FINAL
Engineering Evaluation / Cost Analysis (EE/CA) for
Removal of Mine Wastes at the Idora Mill Site and
Downstream along Beaver Creek,
Shoshone County, Idaho

March 2010

Prepared by:
Department of Environmental Quality
Coeur d'Alene Regional Office
2110 Ironwood Parkway
Coeur d'Alene ID 83814

Figure 6: Location of Prichard Repository in relation to Idora Mill site and proposed haul route.

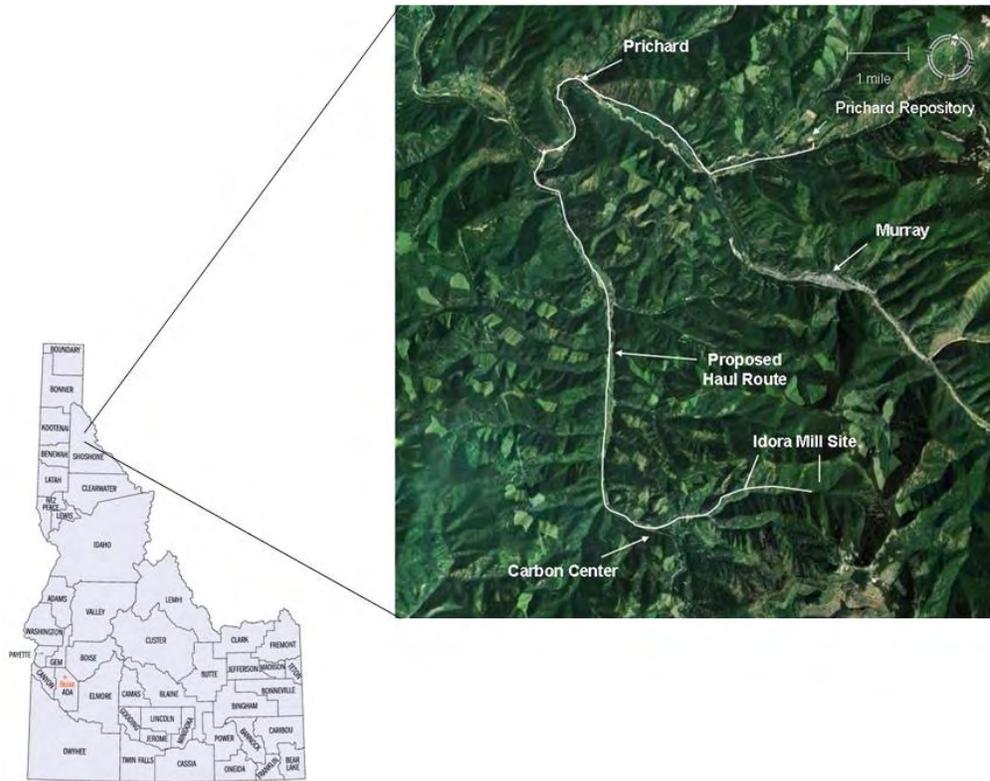
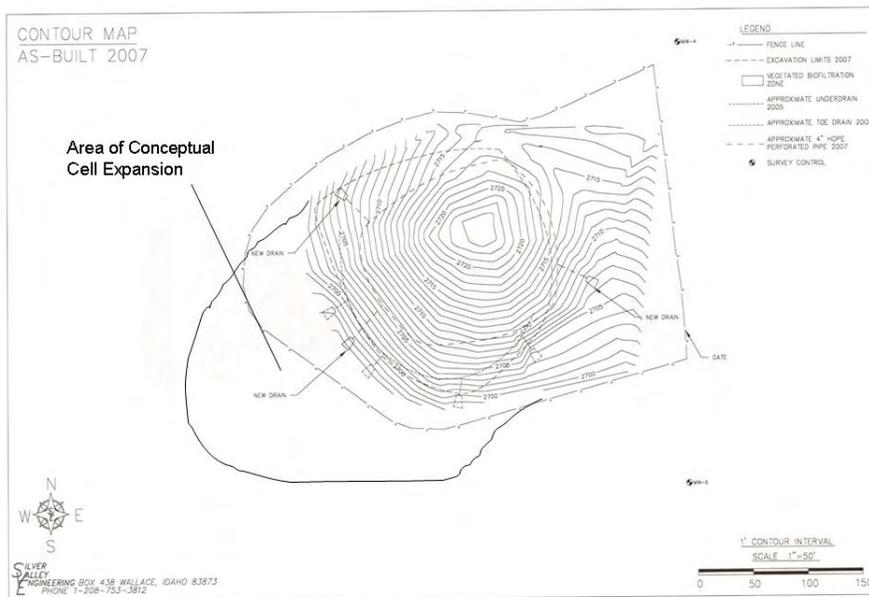
It was suggested that since the Prichard Repository was proposed as the on-site watershed repository, more information should be provided on its location and current configuration. An additional paragraph was added to section 6.1.4 describing the Prichard Repository. Two figures were added showing the location of the removal area, the repository and the proposed haul route and another showing the Monarch Cell of the repository “as built” after the Beartop wastes addition and the conceptual area of cell expansion for the Idora wastes.

- Since you are using an existing repository (?), recommend you discuss in greater detail and include on appropriate site figure.
- Recommend you include typical drawings showing where proposed work would occur for each alternative, components of the the protective barrier, and surface water control features.

Figure 8. Location of Alternative 2 fencing, soil barriers and required road removal.

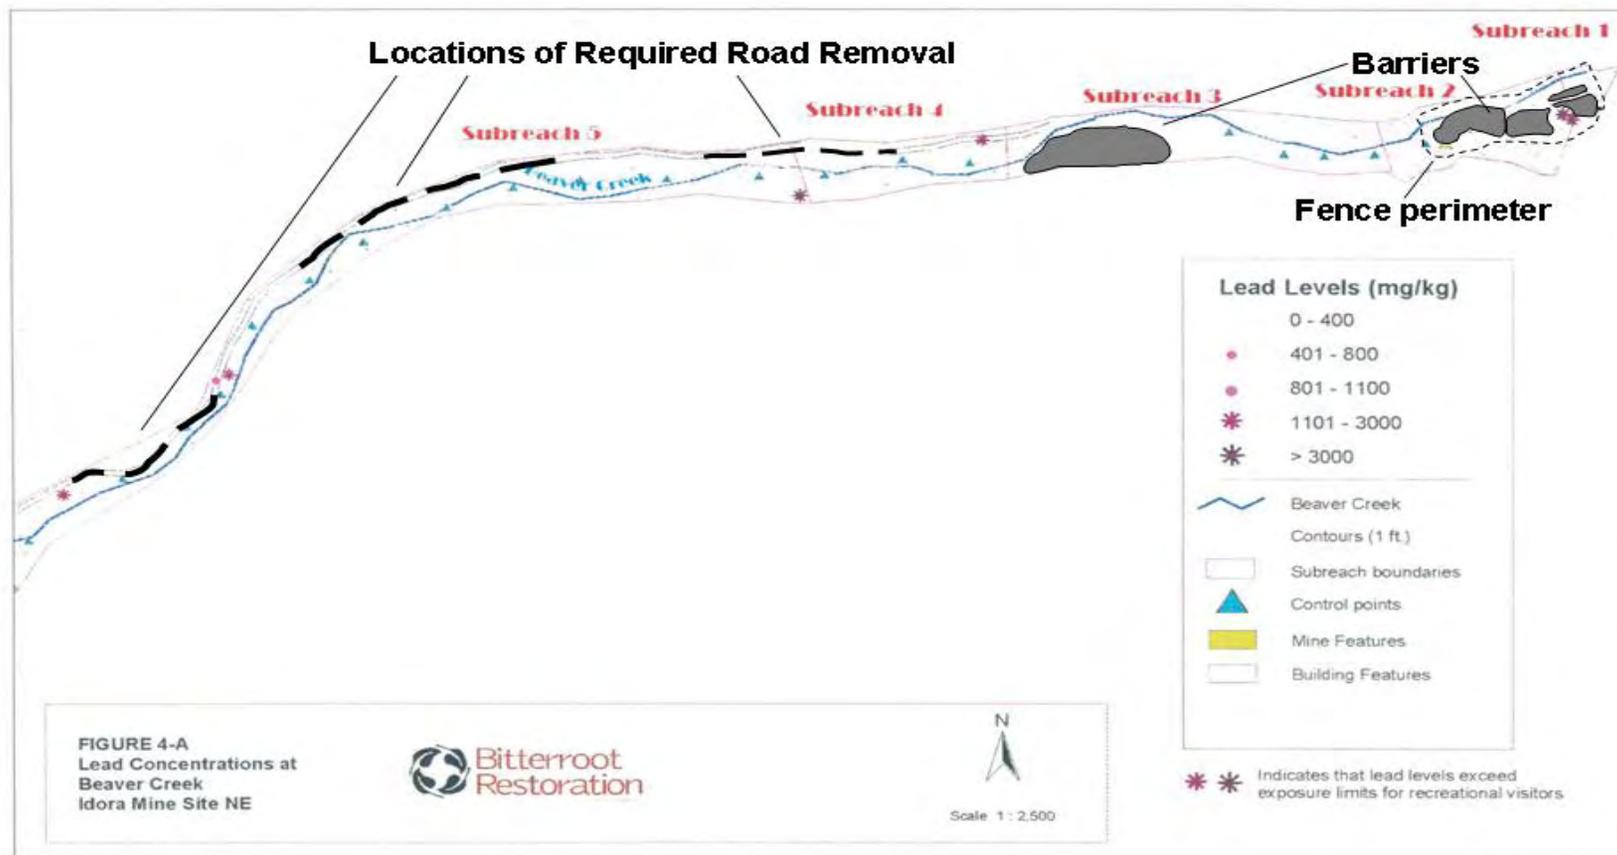
It was suggested that typical drawing showing the actions of each action alternative be included as well as barrier and BMP typical drawings. Four figures were added to section 6.2 to illustrate alternatives 2,3 and 5 and by reference alternative 4. The project is too early in the design phase to supply the additional typical drawings requested.
